Addendum Number: 02**Addendum Issue Date:** January 14, 2026**Owner:** Robinson-Palestine Water Commission**Project Name:** Water Treatment Plant and Campus**Project Number:** 0210007.00**Containing:** # Pages; # Drawings; # Specifications

12. SHEET C1 & C2 – PROVIDED as a standalone attachment with the addendum. These sheets pertain to Rte. 1 and Rte. 33 watermain crossing. These sheets were included in the original specifications, as a permit attachment for the aforementioned crossings. The attached sheets with the addendum are a higher resolution version of the of the same sheets that were provided with the original specifications.

PROJECT:
**Robinson-Palestine Water
Commission**

Water Treatment Plant and Campus

4 NORTH ELEVATION

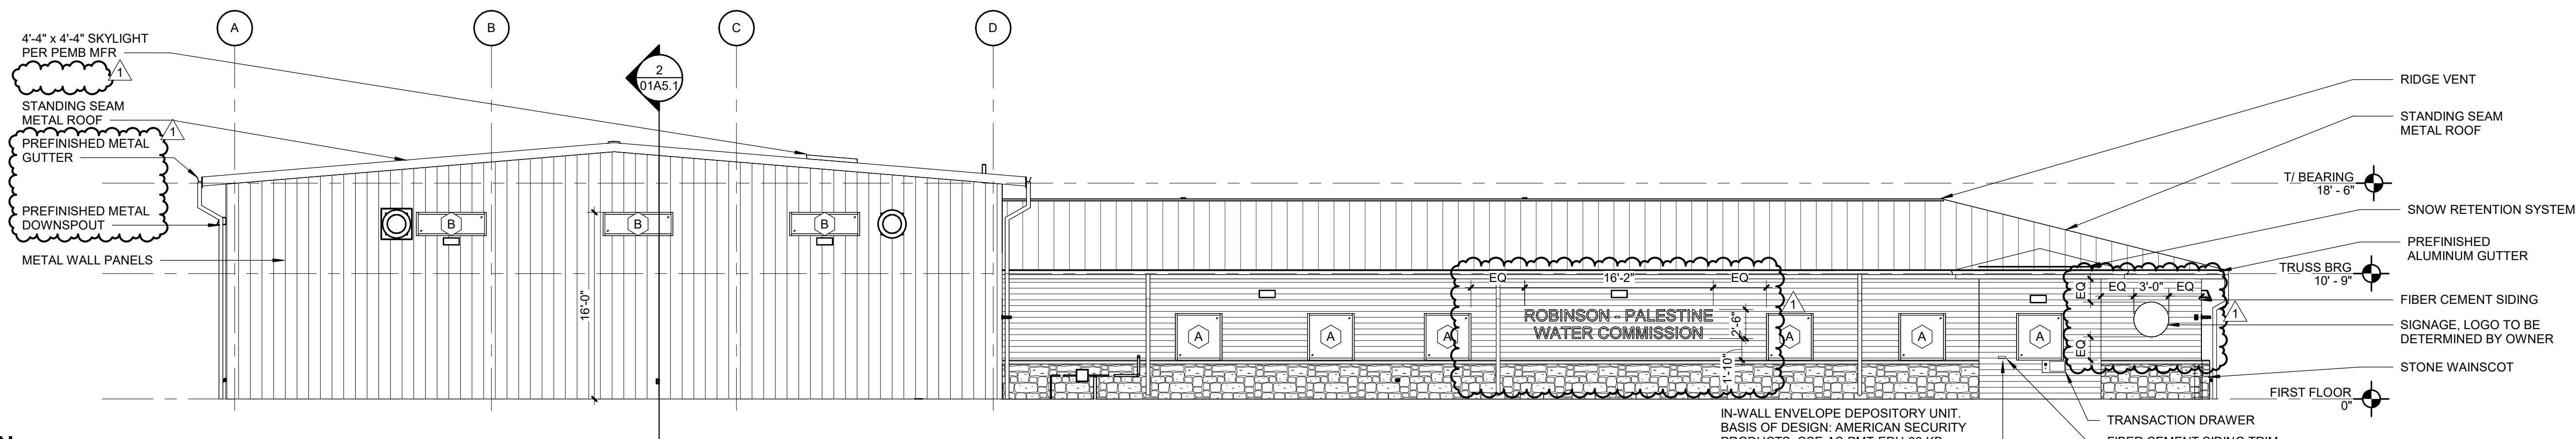
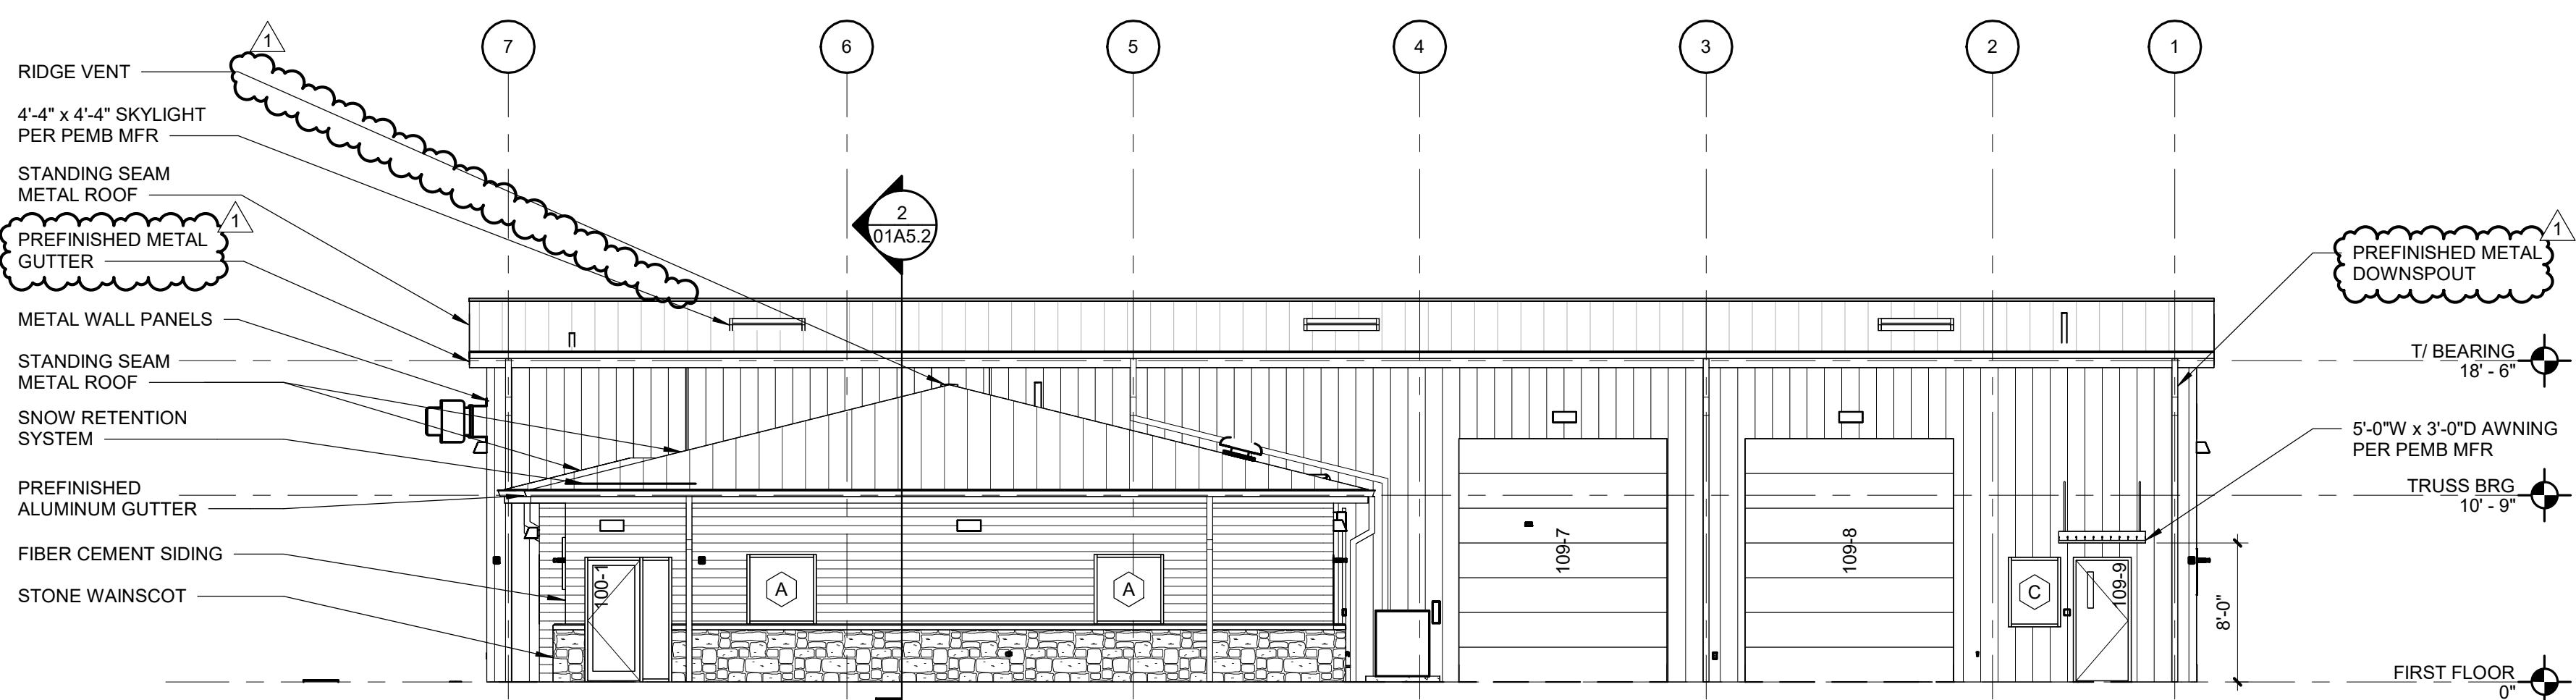
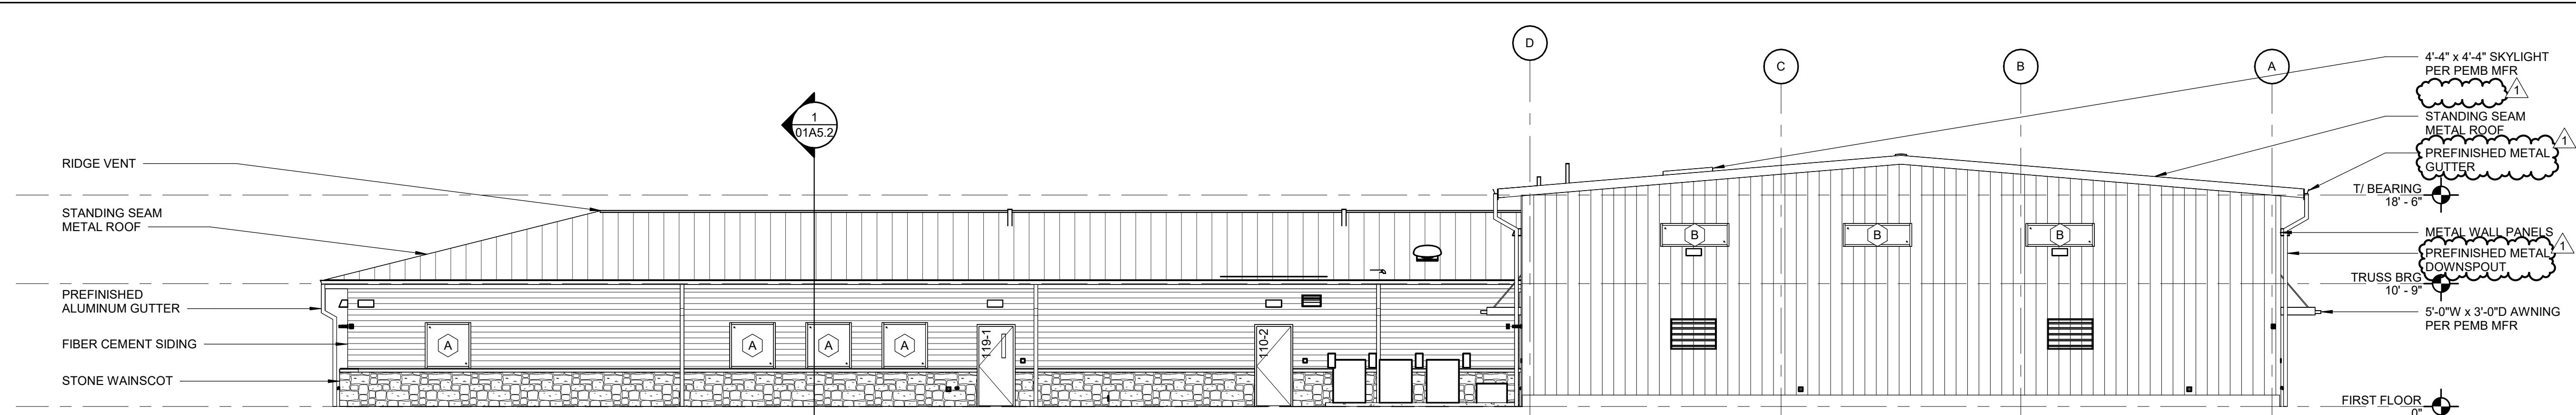
1. Replace Sheet C1.1 and Sheet C2.1 with the attached sheets. Revisions are clouded in the attached drawings.
2. SHEET 01A2.1 – ~~DELETED~~ ridge vent notation at PEMB. REVISED gutter material of PEMB to metal, in lieu of aluminum.
3. SHEET 01A3.1 –
 - a. ~~DELETED~~ ridge vent notation at PEMB. REVISED gutter and downspout material of PEMB to metal, in lieu of aluminum.
 - b. ADD overall dimensions to signage elevations.

01A1.1

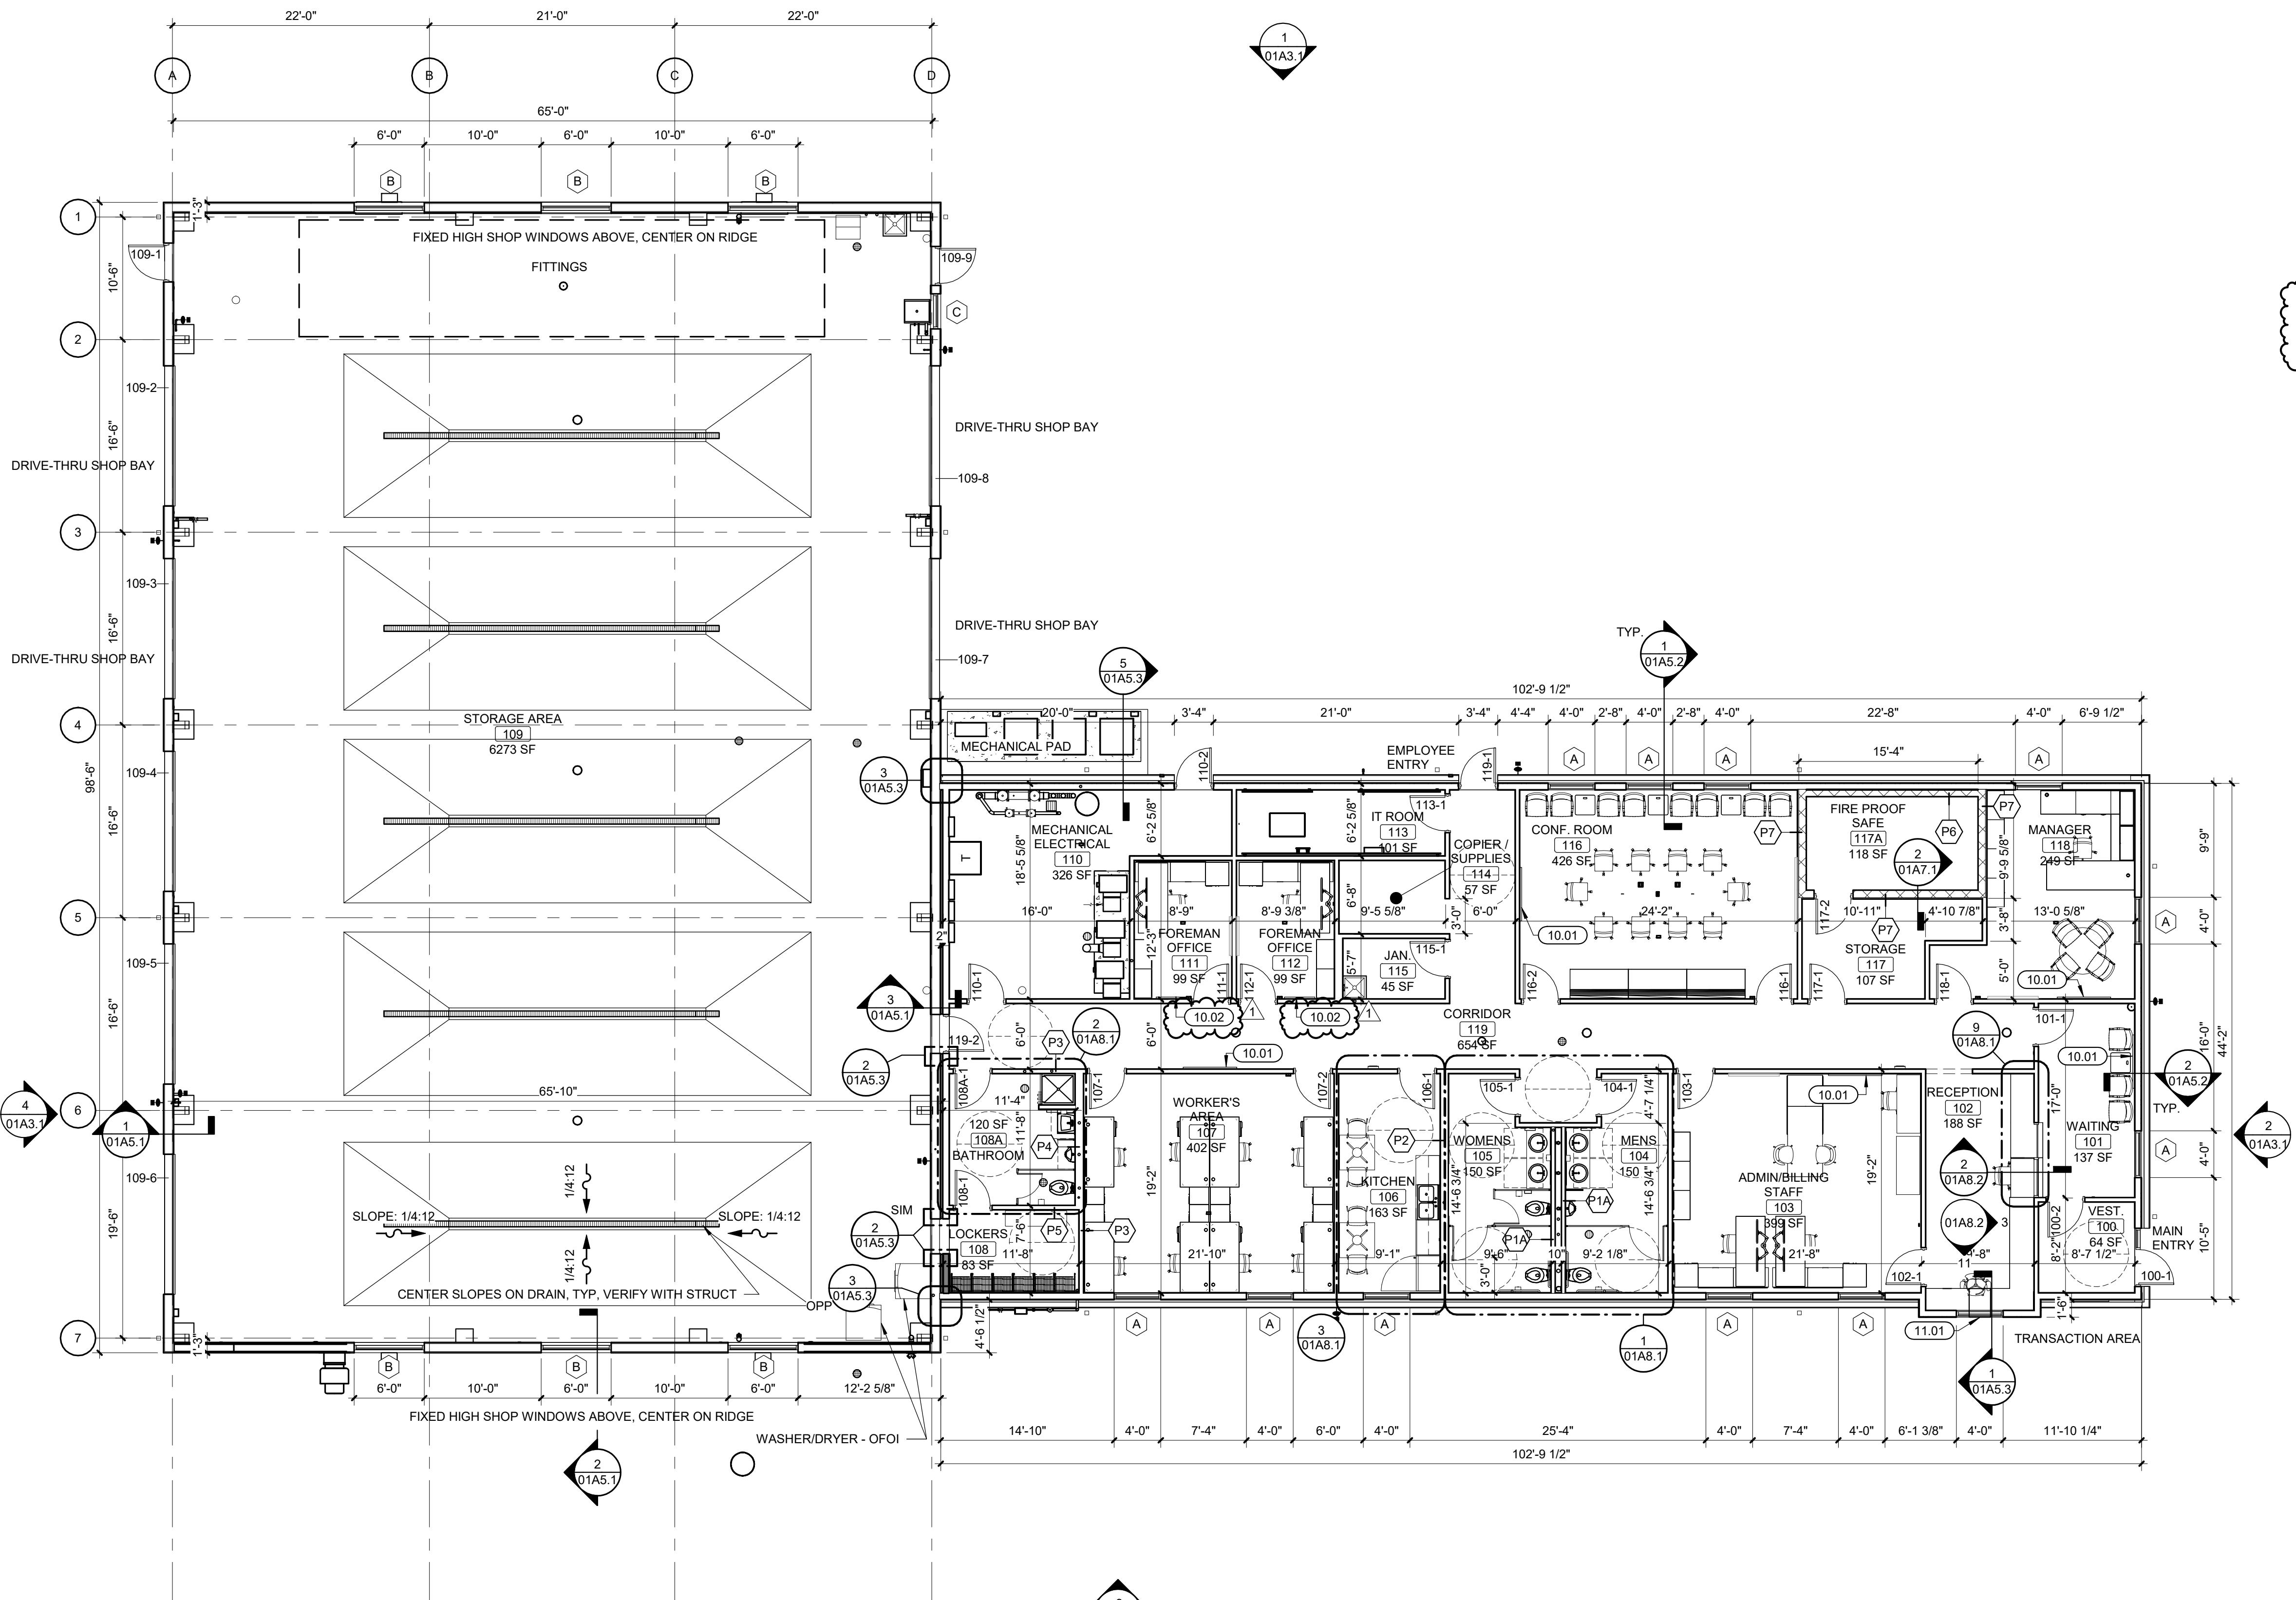
6. SHEET 01A1.1 – REVISED keynote 10.01 to include Basis of Design 55” wall mounted television. ADDED keynote 10.02 to include Basis of Design 32” wall mounted television.
